Subject: **Response to a Portion of Request for Additional Information Letter No. 382 Related to ESBWR Design Certification Application, - DCD Tier 2 Section 3.11 - Environmental Qualification of Mechanical and Electrical Equipment; RAI 3.11-28 S01**

**Response to a Portion of NRC Request for
Additional
Information Letter No. 382 Related to ESBWR
Design Certification Application**

RAI Number 3.11-28 S01

NRC RAI 3.11-28 S01

Figure 1

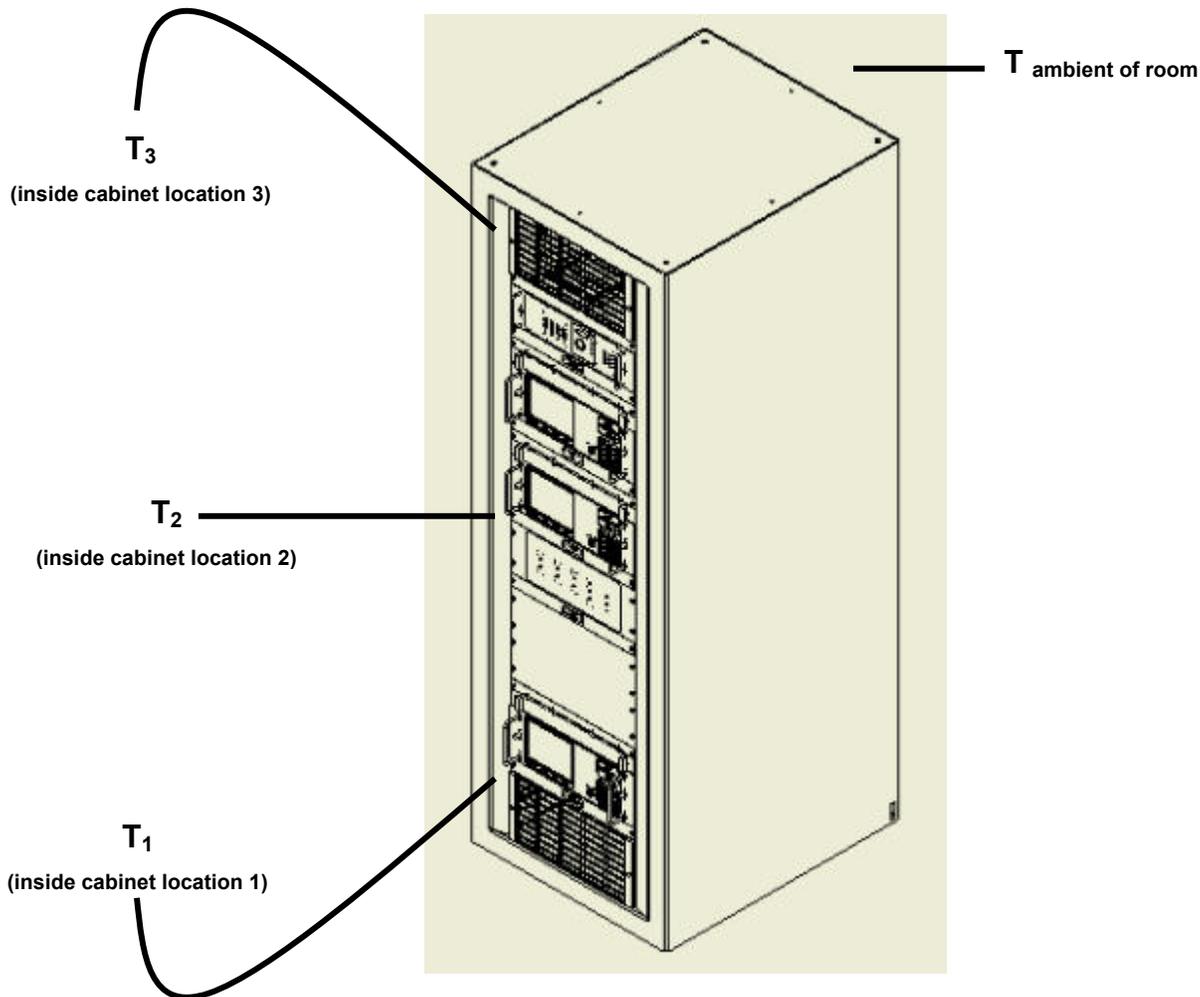
Provide additional details on how the service temperature of electrical equipment, including Computer-based I&C systems, will be determined for the ESBWR. In particular provide details on this process for equipment that is planned to be located inside electrical cabinets/panels in the RB and the CB. Also, discuss how the service temperature will be determined for equipment in harsh environment.

The “service temperature” of electrical equipment, including for computer-based I&C, is the ambient temperature of the environment adjacent to the exterior of the equipment’s physical envelope (e.g.; cabinet or enclosure). It is understood that the temperature inside an energized electrical equipment cabinet will be higher than the ambient room temperature of the environment in which it is exposed (see the example in Figure 1 below).

The temperature increase values at certain locations and gradients between locations inside a cabinet is based on many variables, including (but not limited to); thermal conductivity and emissivity of the cabinet itself, number and location of chassis installed, power output or thermal load of each chassis, airflow either natural or forced around and through the cabinet, as well as other heat sinking methods not involving airflow directly.
